Additional/Revised Material Submittal Form

Permit (File) Number: DSRFY2024-0010 Design Professional in Charge: Dale Binning, Architect
Project Name: Foothills Functional Medicine
Project Address: 10178 Carlton Bay Drive Garden City, Idaho, 83714
Contact email: binningarchitects@gmail.com Contact Phone: (208) 383-0209

DESIGN REVIEW
RESUBMITTAL

REVISIONS PER DESIGN REVIEW ZOOM MEETING
AUGUST 5, 2024

DESIGN REVIEW
DSRFY2024-0010

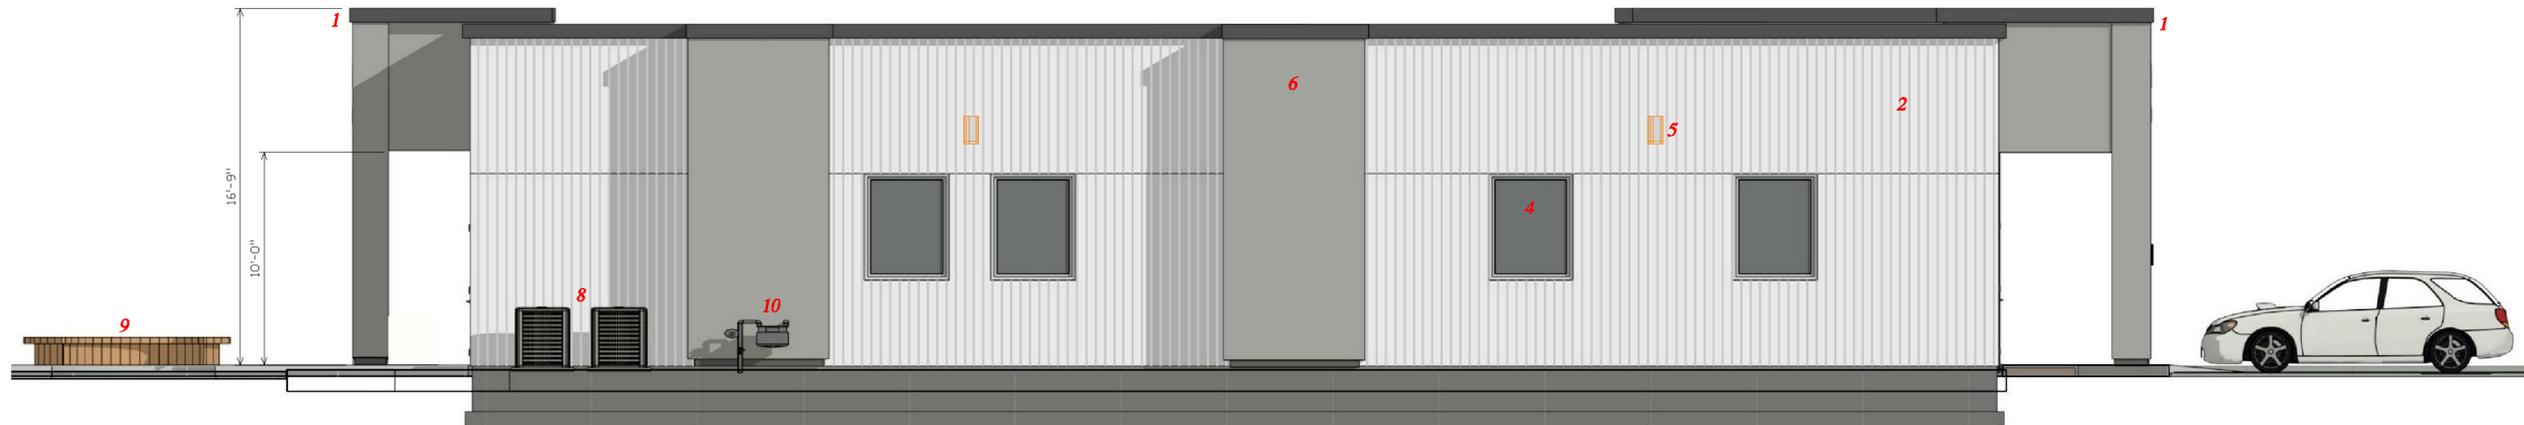
1. S1-DR Site Plan: added plaza, 4-place bike rack, sidewalk planter, drive aisle dimensions
2. C2.0 Civil Site Plan: added cobble drain, plaza, drive aisle dimensions, Idaho Power Transformer
3. L1.1: Landscape Plan: added plaza landscaping, additional screening for a/c units, tree at end of driveway
4. A-1DR: Exterior Elevations: extended entry elements over roof, sidewalk planter, vertical elements
5. A-2DR: Floor Plan: added plaza, sidewalk planter at entry, added vertical wall panels, bicycle parking
6. NOTE: All items discussed in our consultation zoom meeting have been addressed on these plans.

A-2DR

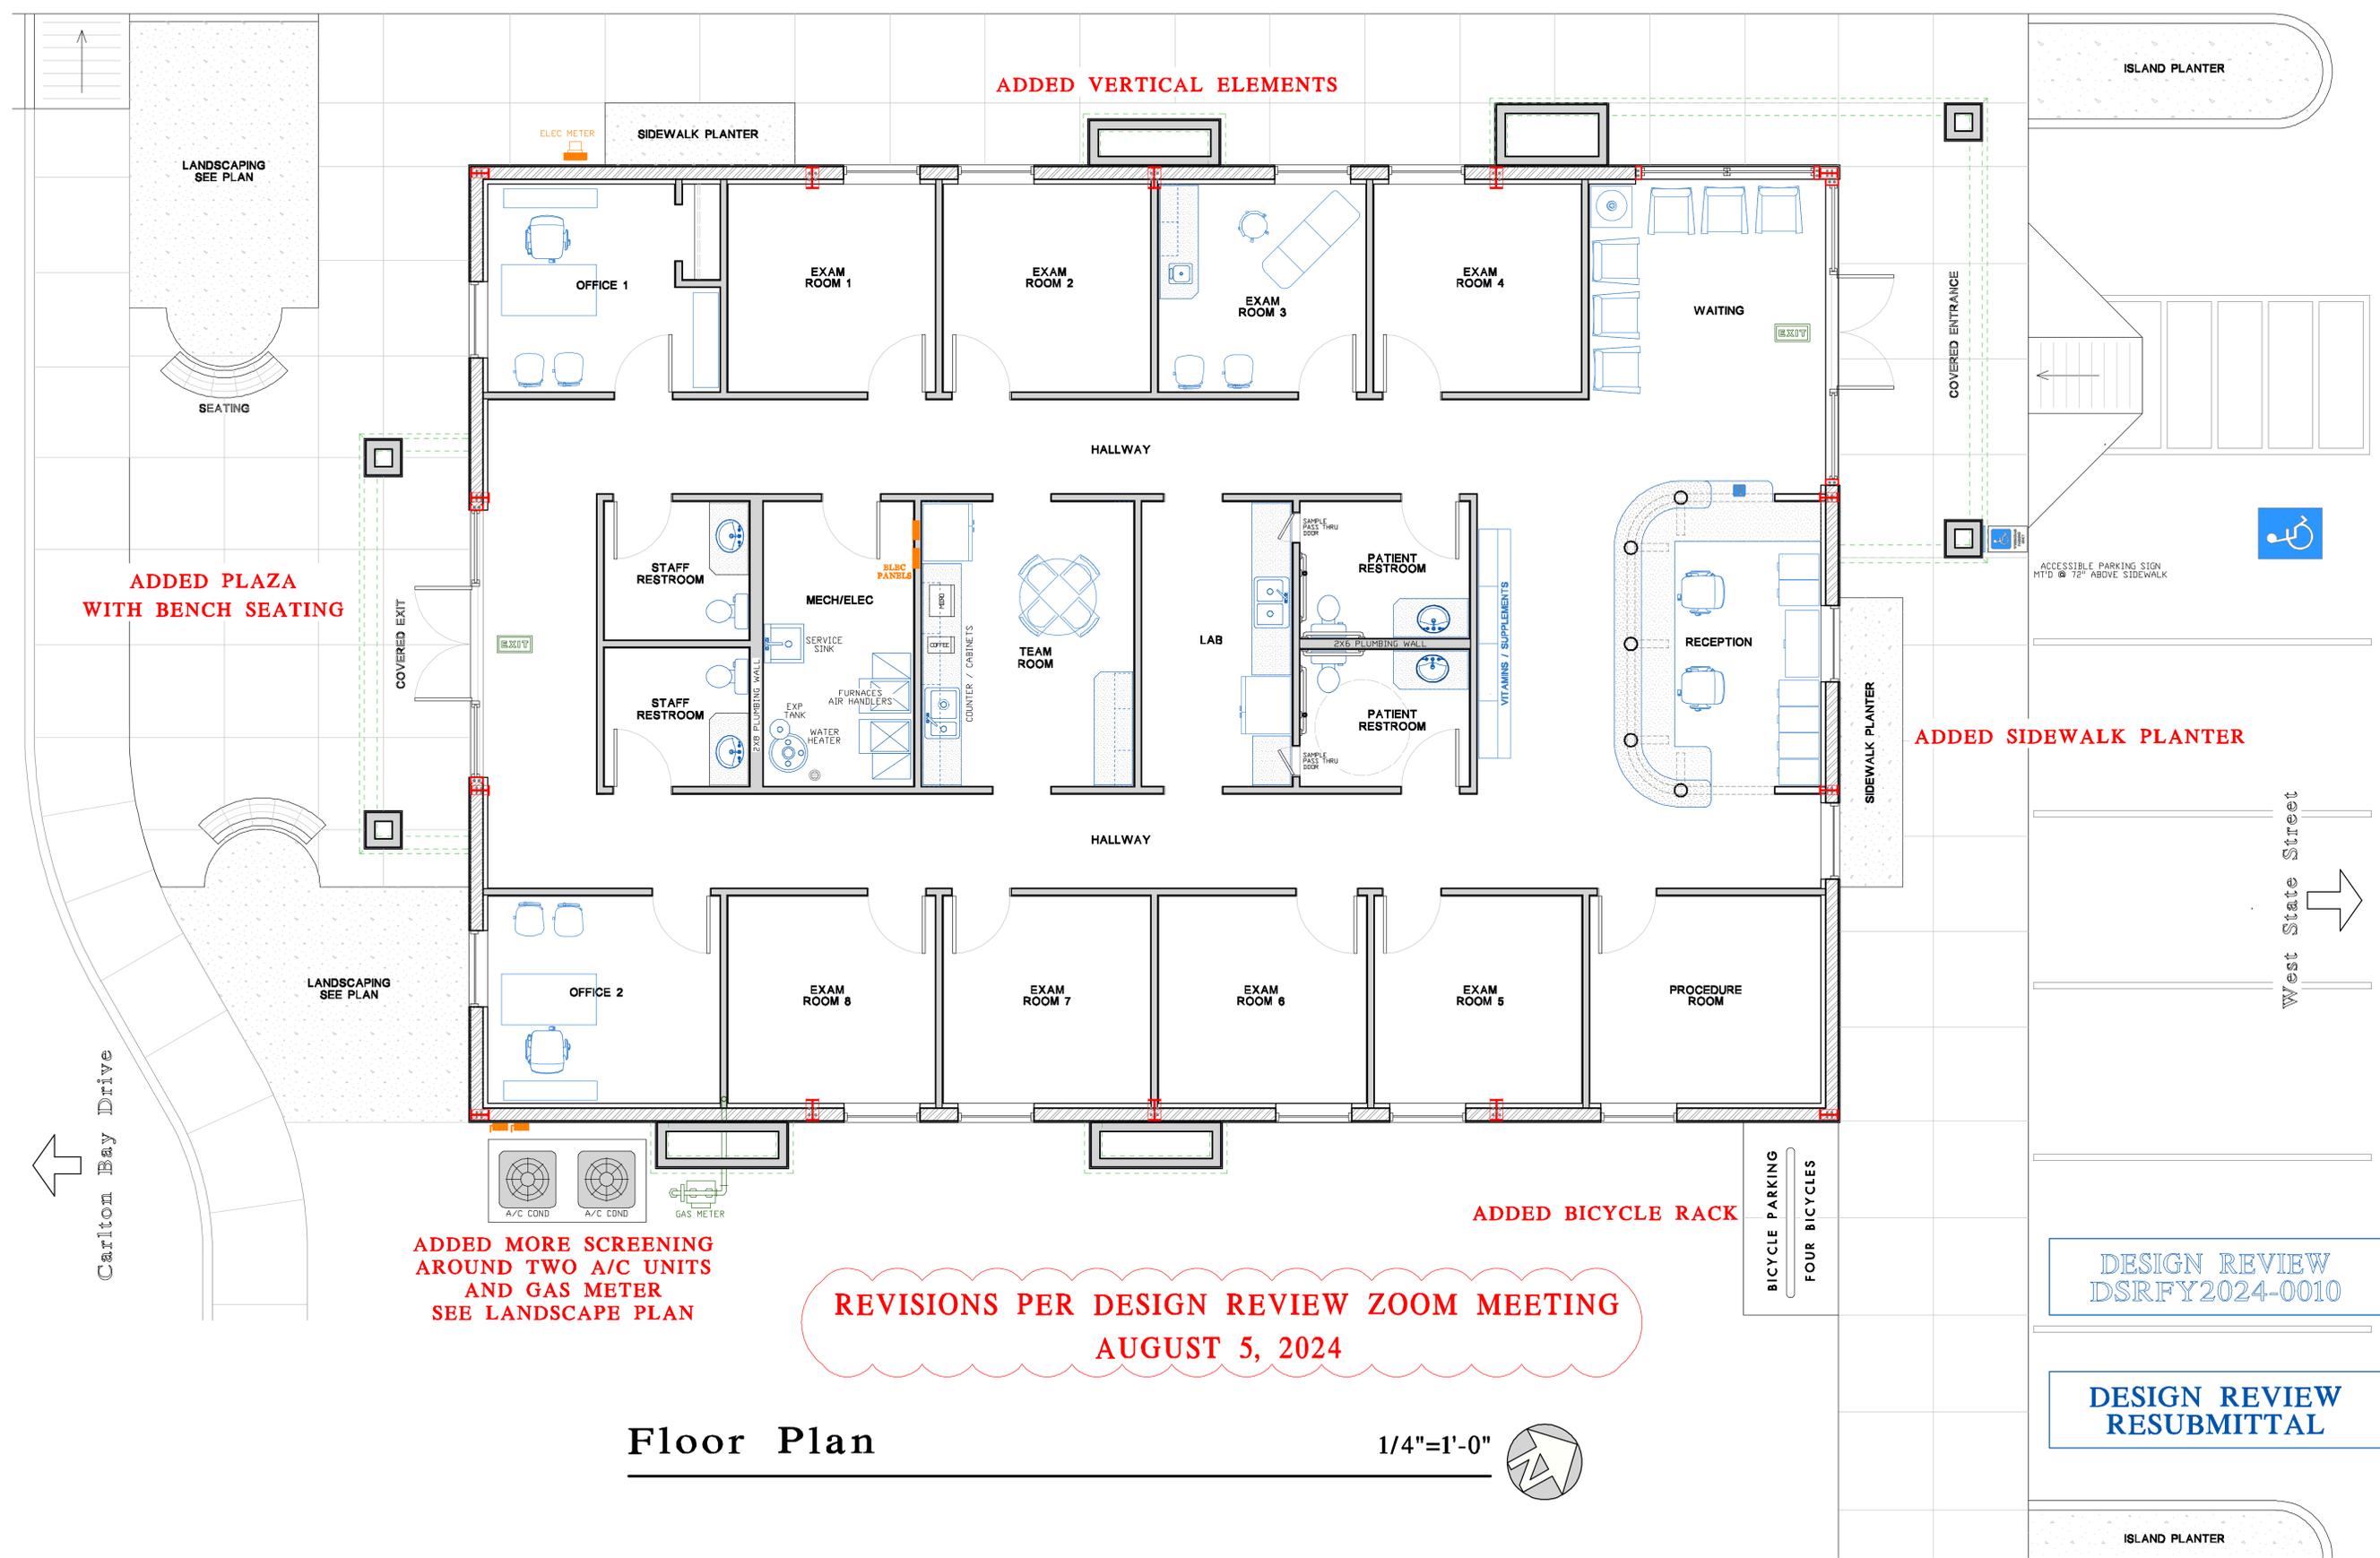
ADDED TREE AT END OF DRIVEWAY
NEXT TO MONUMENT SIGN
SEE LANDSCAPING SITE PLAN

ADDED VERTICAL ELEMENTS

ADDED PLAZA
WITH BENCH SEATING

ADDED SIDEWALK PLANTER

ADDED BICYCLE RACK

ADDED MORE SCREENING
AROUND TWO A/C UNITS
AND GAS METER
SEE LANDSCAPE PLAN
